MEMPHIS AND SHELBY COUNTY OFFICE OF PLANNING AND DEVELOPMENT

STAFF REPORT

CASE NUMBER: PD 11-309

REQUEST: Major Modification to the approved site plan

Site Plan

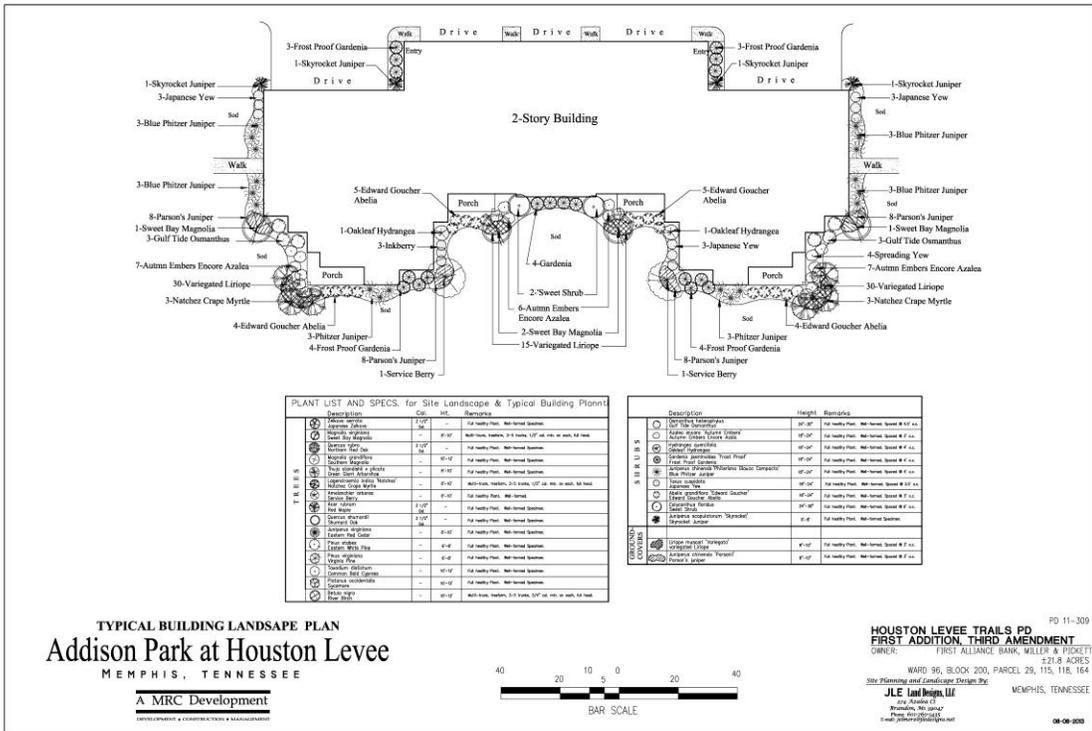
OPD's primary concern is the open space requirement; developments of 15 acres or more require open space; furthermore, the open space must be reasonably accessible and centrally located. OPD agrees that the applicant has provided open space; however, it is recommended that the applicant locate the open space amenities (tennis court, play area) in a more accessible location.

Sub-section 6.2.1B requires that formal open space be offered in developments of 15 acres or more. In this case OPD estimates that the intent is fulfilled as illustrated by the site plan by way of the clubhouse, pool, tennis court and play area; however, these areas must be more centrally located. Sub-section 6.2.3E requires that formal open space be reasonably accessible to the lots/residents. With that, OPD recommends that the tennis area and play area be more centrally located and more accessible to a greater percentage of the residents.

- C. The play area shall be removed from the required landscape buffer at the most southern perimeter of the site.*
- D. The proposed play area and proposed tennis court shall be centrally located per Sub-section 6.2.3E of the UDC.*
